Product Discontinuation Notices

No. 2013029CE

Discontinuation Notice of Back-connecting Sockets PY14(QN)-3 series.

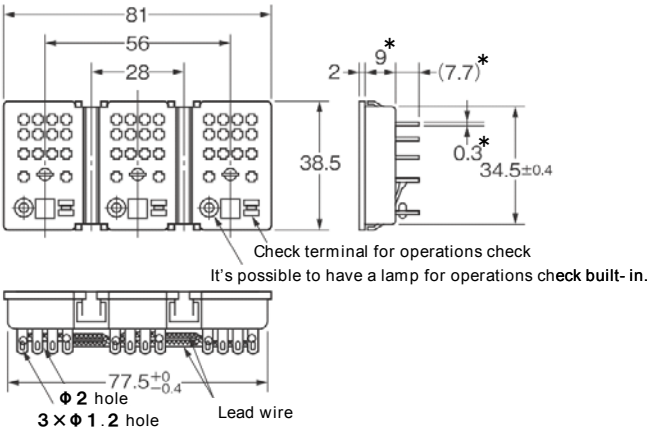
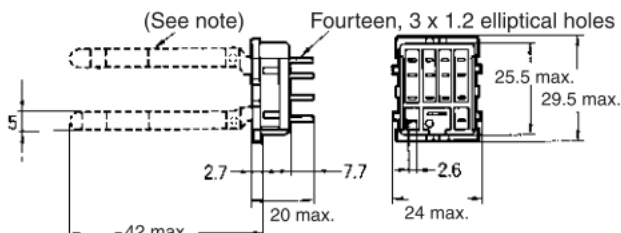
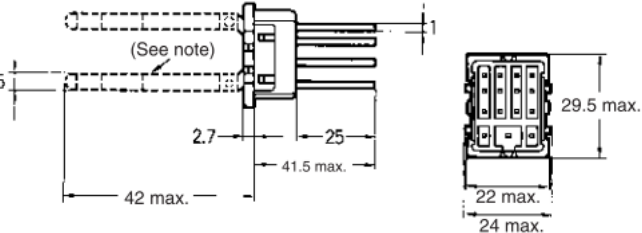
Please note that PY14(QN) FOR MY does not have a check terminal for operation check.

Dimensions and Mounting dimensions are also different.

Please use 3 pieces of Back-connecting socket PY14(QN) FOR MY for a replacement.
